Table 1: Responses to Comments from Government Department on Planning Application No. A/NE-LYT/816 (19 February, 2024)

Drawing No. STK 002B

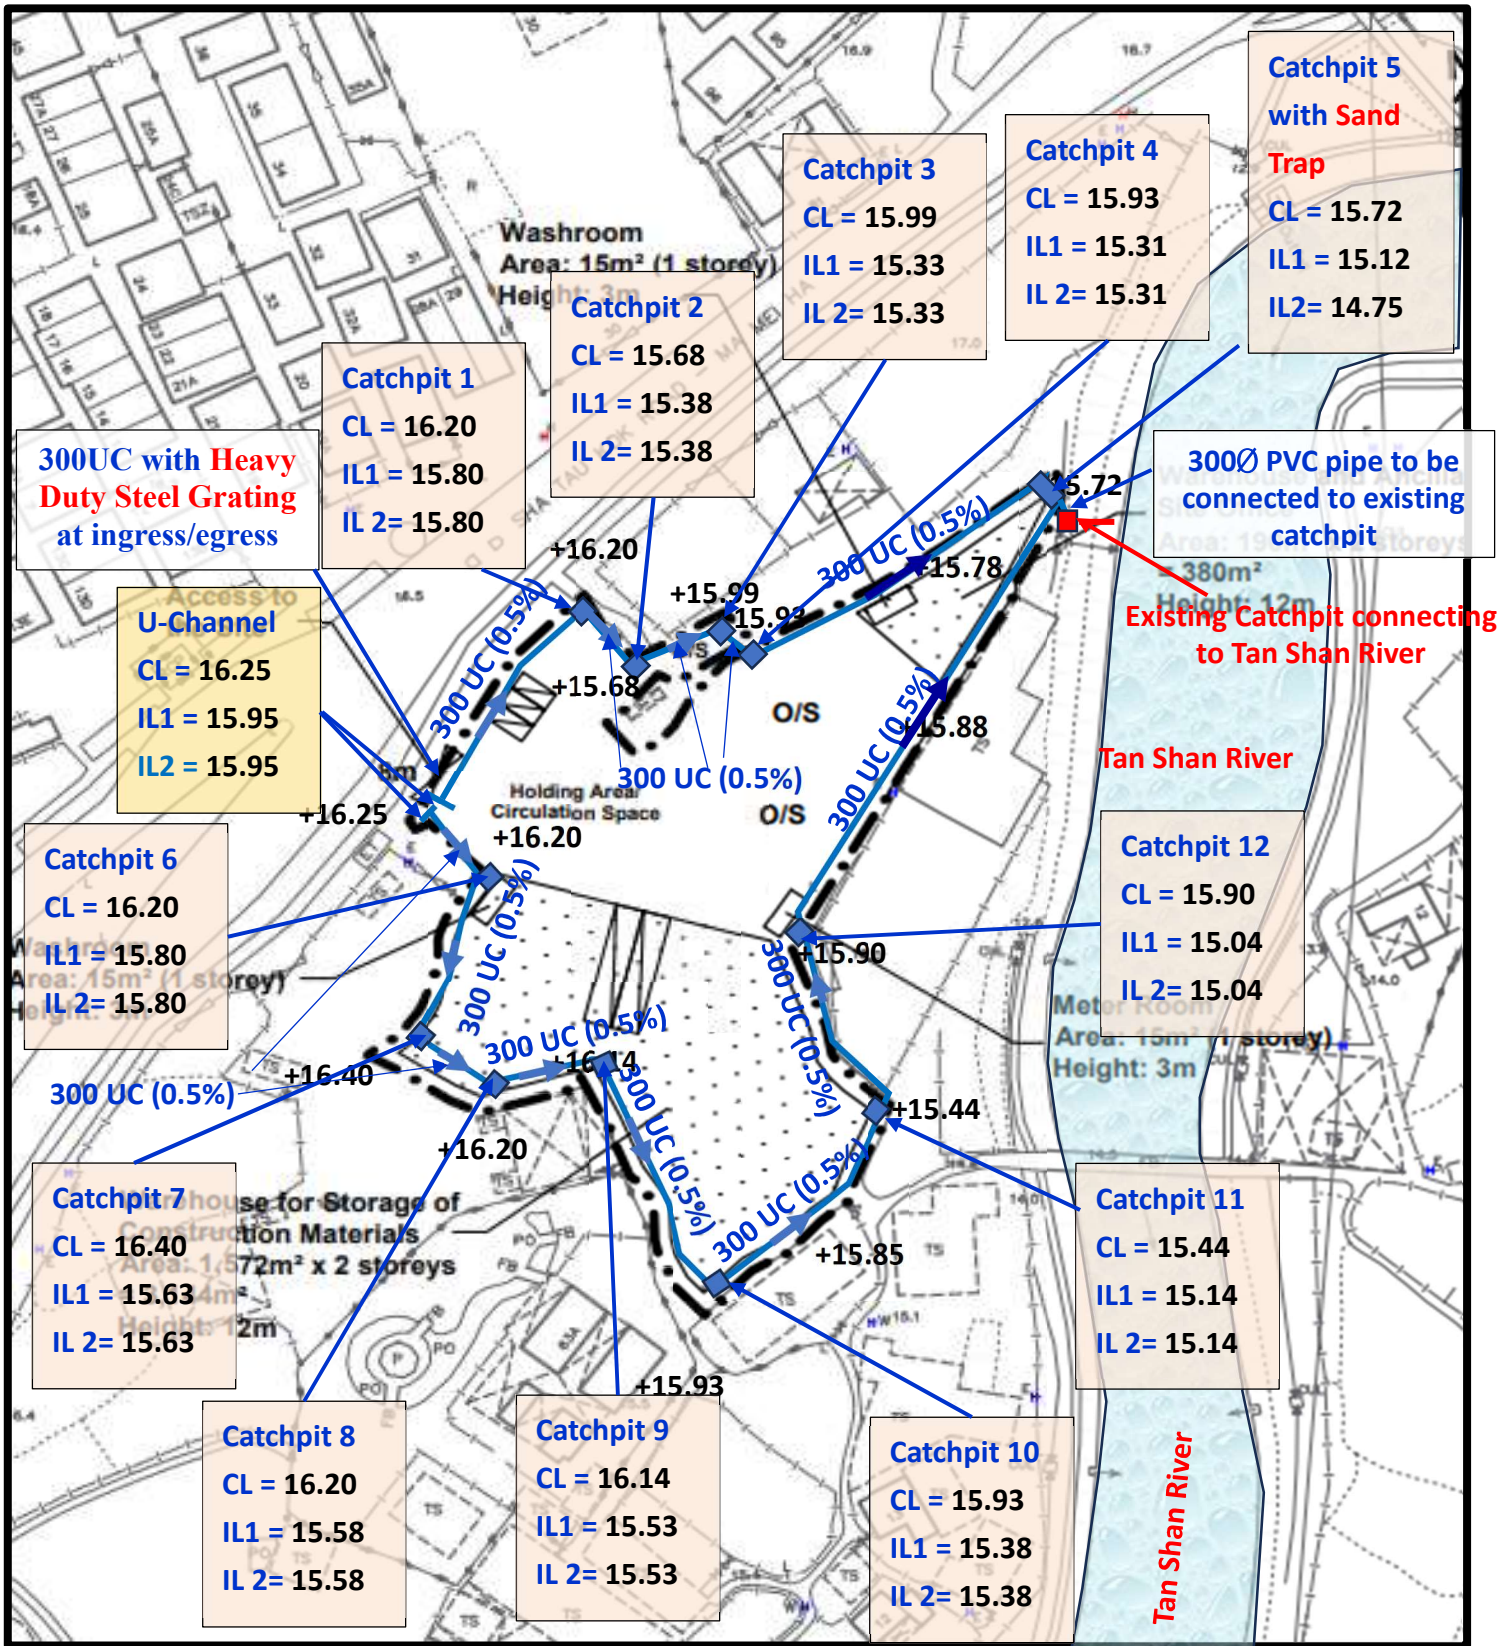
<p>(b) The project proponent should demonstrate clearly that the proposed development would not cause any increase in the flooding susceptibility of the adjacent areas and Tan Shan River.</p>	<p>(b) Since there is no change of catchment areas. Therefore, there is no additional run-off. Tan Shan River is a proper river with adequate capacity to cater the stormwater from the adjacent areas.</p>
<p>(c) Please also be advised on the following general requirements in the drainage proposal:</p>	<p>(c) Noted.</p>
<p>(i) Surface channel with grating covers should be provided along the site boundary;</p>	<p>(i) All surface U-channels with concrete cover will be provided along the site boundary and heavy duty steel grating will be provided at the vehicular entrance/exit point.</p>
<p>(ii) A drainage plan should be provided clearly showing the size, levels and routes of the proposed drainage. The details (invert</p>	<p>(ii) Drawing No. STK-002B – Drainage Plan (see Annex 5) is submitted showing the proposed drainage system for the site including the</p>

COMMENTS	RESPONSES
level, gradient, general sections etc.) of the proposed drain/surface channel, catchpits and the discharge structure shall be provided;	ground levels, invert levels and the gradients.
(iii) The cover levels of proposed channels should be flush with the existing adjoining ground level;	(iii) Topographic survey has been carried out, all proposed drainage levels will flush with the existing adjoining ground levels.
(iv) A catchpit with covers should be provided where there is a change of direction of the channel/drain. The details of the catchpit with covers shall be provided;	(iv) Catchpits are provided for all connecting the proposed U-channels where there is a change of flow direction.

Sketch No. 1

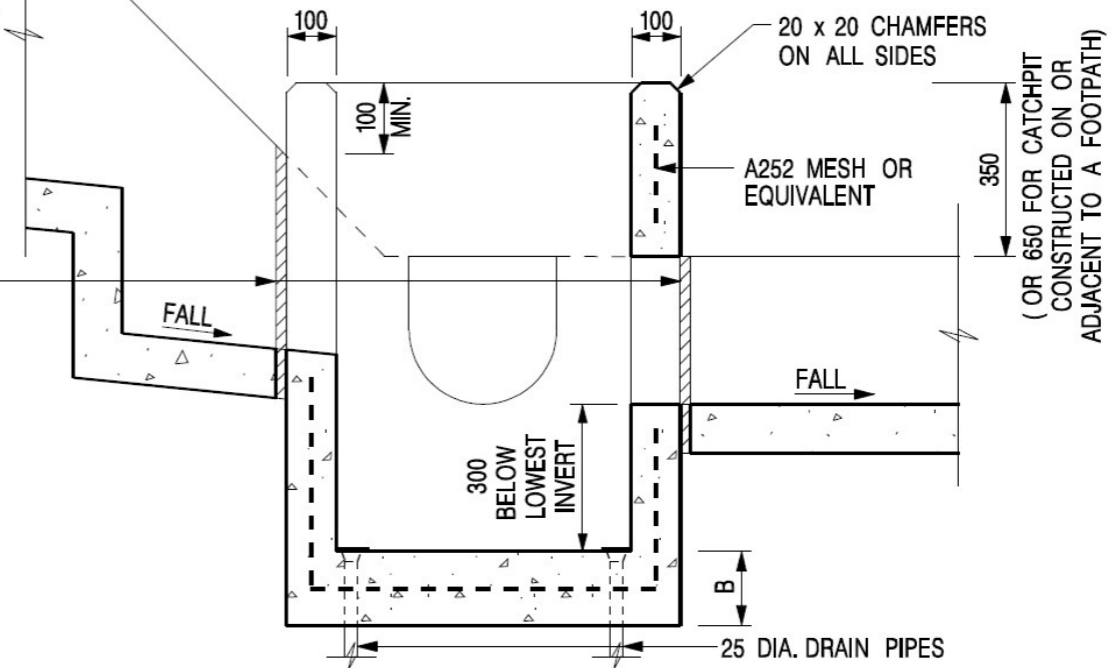
(v) Catchpits with sand trap shall be provided at the outlets of the proposed drainage system. The details of the catchpit with sand trap should be provided;	(v) Catchpit No. 5 with sand trap will be provided where is the outlet of the proposed drainage system. The details is shown on the attached Sketch No. 1.
(vi) The applicant should check and ensure that the existing drainage downstream to which the proposed connection will be made have adequate capacity and satisfactory condition to cater for the additional discharge from the captioned site. He should also ensure that the flow from this site will not overload the existing drainage system;	(vi) The stormwater from the application will be finally discharged onto the existing streamcourse (Tan Shan River) as original since there is no change of catchment areas. Therefore, there is no additional run-off. Tan Shan River is a proper river with adequate capacity to cater the stormwater from the adjacent areas.

Sketch No. 2

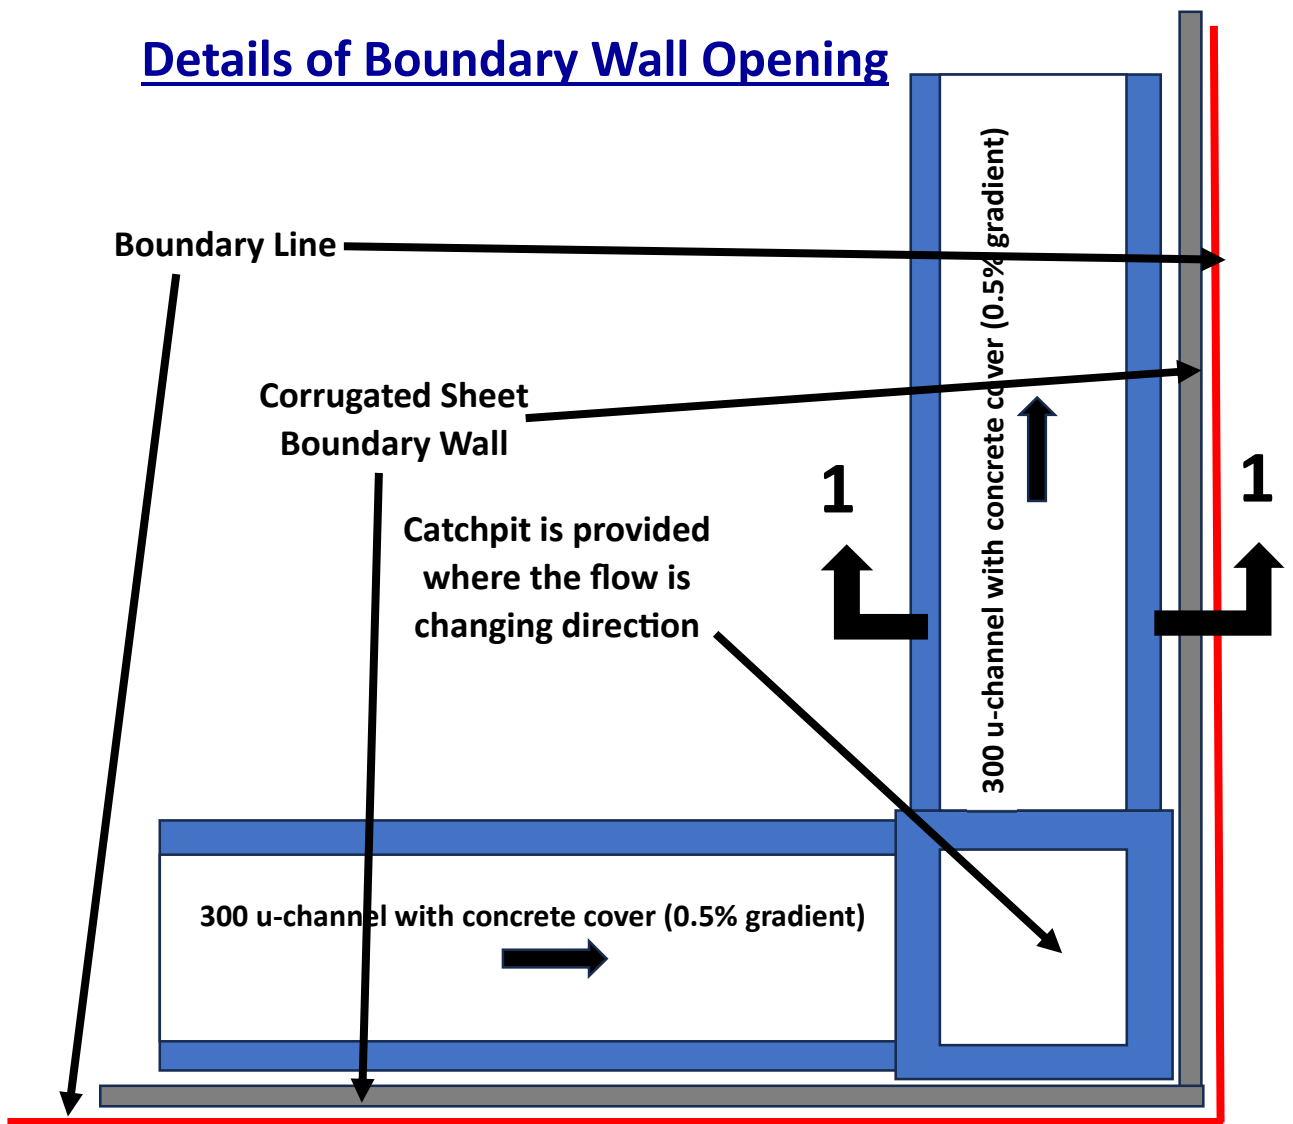
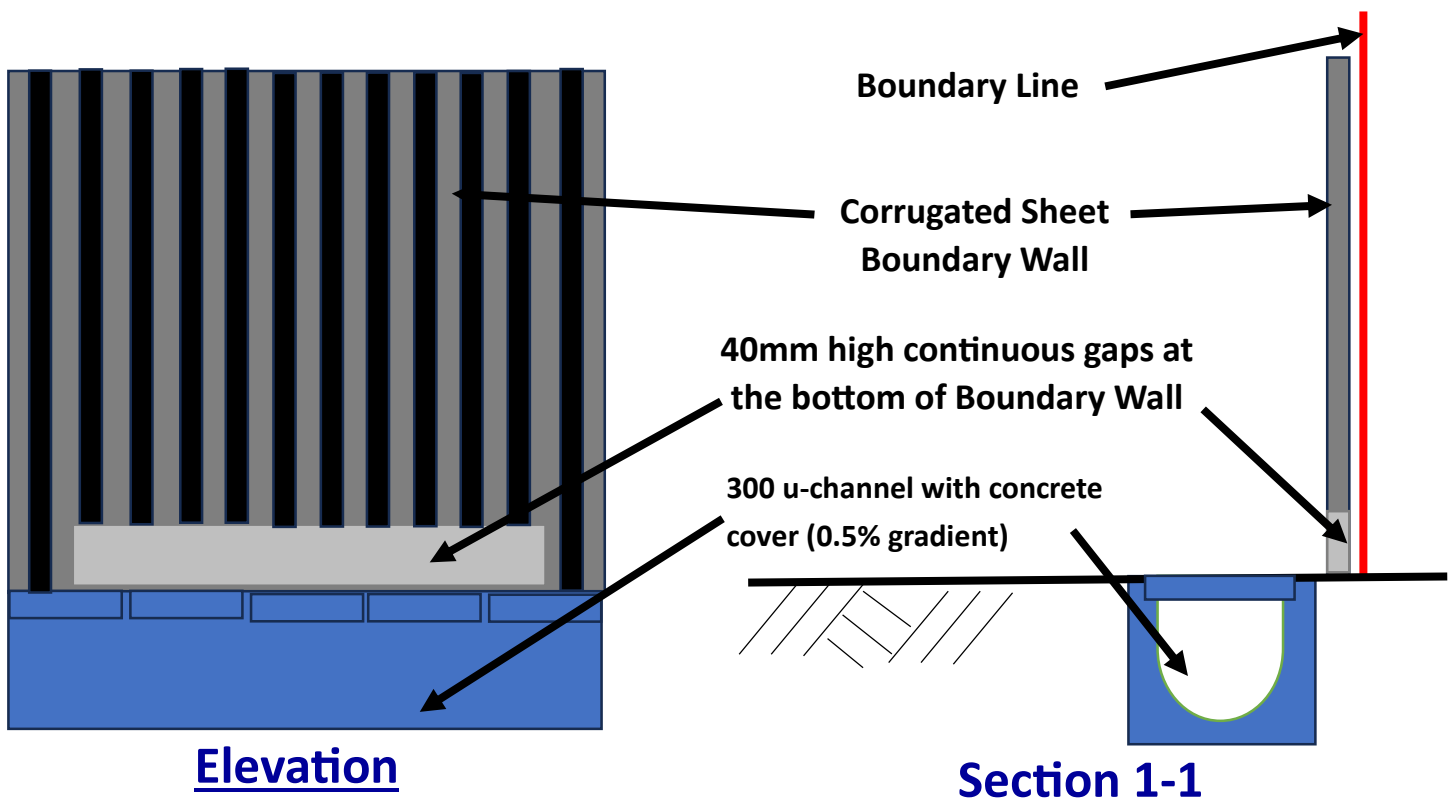
(vii) The applicant is reminded that where walls are erected or kerbs are laid along the boundary of the same, peripheral channels should be provided on both sides of the walls or kerbs, and/or adequate openings should be provided at the walls/kerbs to allow existing overland flow passing through the site to be intercepted by the drainage system of the site with details to be agreed by DSD, unless justified not necessary;	(vii) U-channels will be constructed inside the boundary wall and openings will be provided to collect run-off from adjacent catchpit. A typical details of opening (Sketch No. 2) is attached for reference.

Site Photos

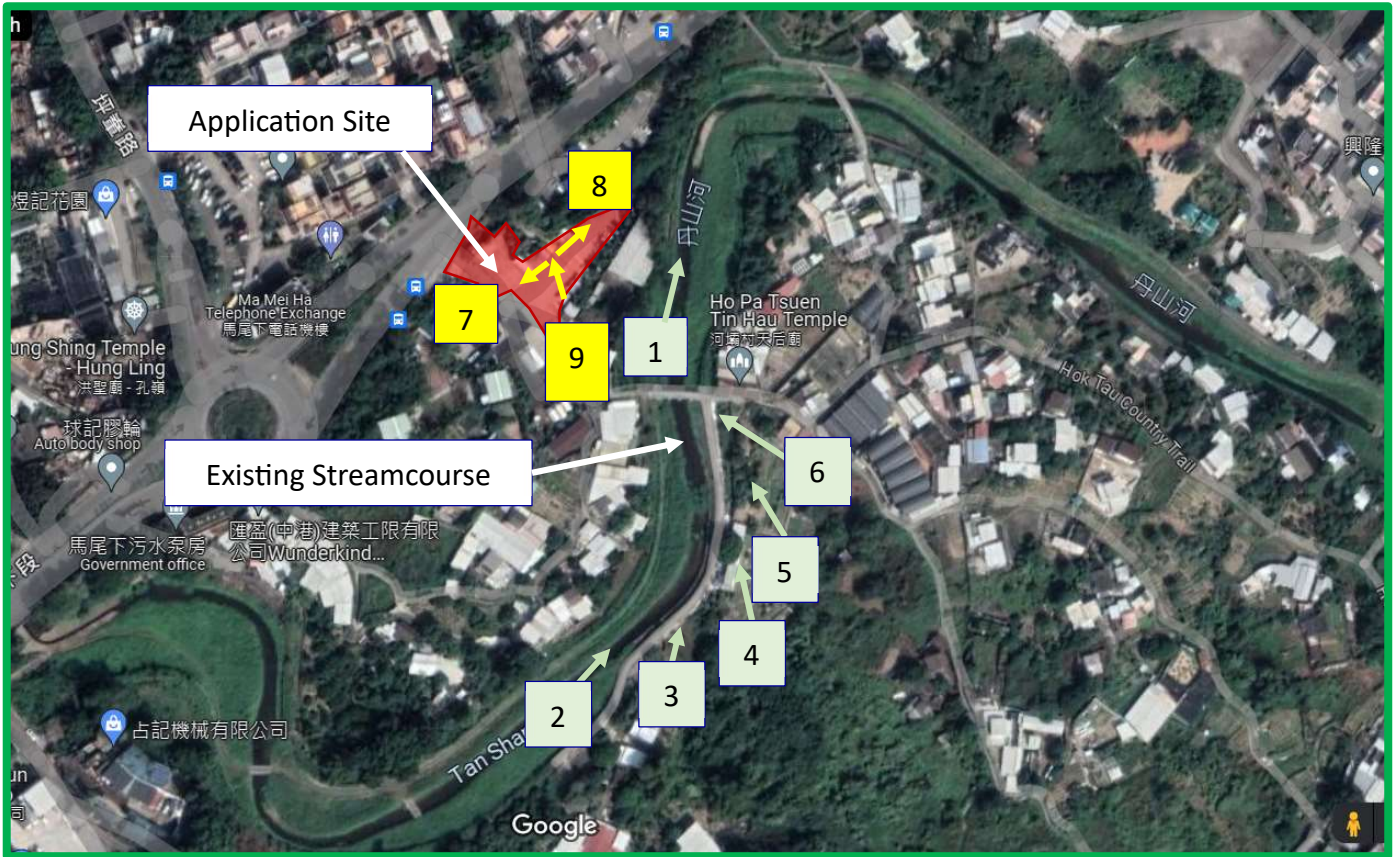
COMMENTS	RESPONSES
<p>(xiv) Photos should be submitted clearly showing the current conditions of the area around the site, the existing drainage/flowpaths around the site, the proposed drainage from the site to the downstream existing watercourse and the existing watercourse at about 20m intervals. The locations of the camera and the direction of each photo should also be indicated on a plan.</p>	<p>(xiv) Site photos are attached showing the location of the application site and the existing steamcourse nearby.</p>
